## CITY OF KELOWNA

# MEMORANDUM

<b>APPLICATION NO.</b> Z08-0084	<b>OWNER:</b> Ambrosi Properties Ltd.
<b>AT:</b> 1821 Ambrosi Road      1869 Ambrosi Road	<b>APPLICANT:</b> The Mission Group
1833 Ambrosi Road      1877 Ambrosi Road	
1845 Ambrosi Road      1885 Ambrosi Road	
1857 Ambrosi Road      1887 Ambrosi Road

**PURPOSE:** TO REZONE THE SUBJECT PROPERTY FROM RU1 – LARGE LOT HOUSING ZONE TO RM5 – MEDIUM DENSITY MULTIPLE HOUSING ZONE TO FACILITATE THE CONSTRUCTION OF 50-UNIT TOWNHOME PROJECT.

1 BASEMENT/GARAGE LEVEL SITE PLAN  
1-10-21

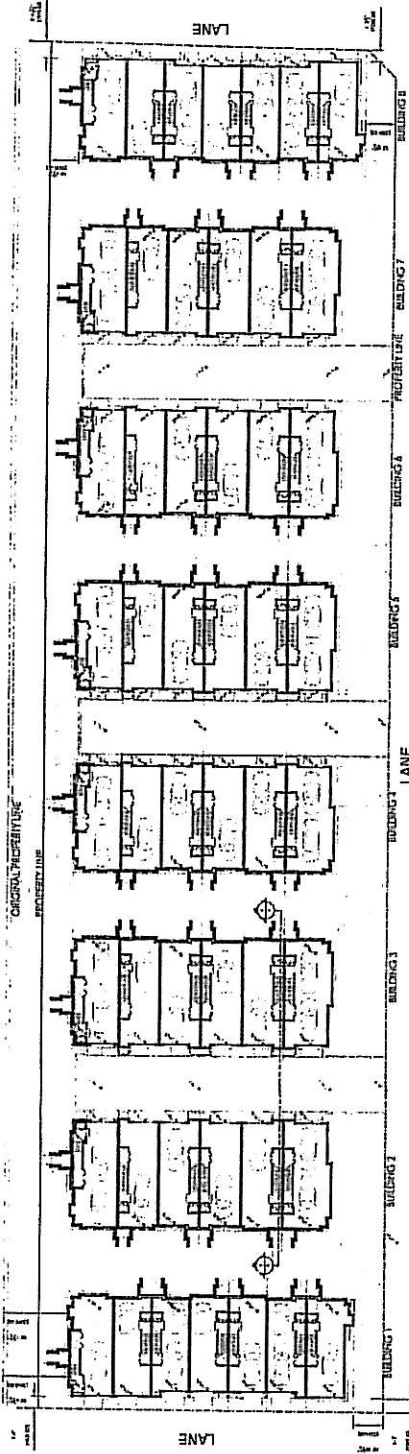
- (a) The developer must obtain the necessary permits and have all existing utility services disconnected prior to removing or demolishing the existing structures.
- (b) The development will be required to contain and dispose of site generated storm water on the site by installing a ground recharge system consisting of drywells and perforated pipe bedded in drain rock.
- (c) Should traffic conditions dictate, the City reserves the right to limit the access onto Springfield Road to right turns only.
- (d) The application to vary the rear yard setback from 6.0m to 3.768m does not compromise works and utilities servicing requirements.
- (e) The application to vary the setbacks from 9.0m to 3.2m, 6.0m to 3.1m and 4.5m to 1.2m, do not compromise works and utilities servicing requirements.
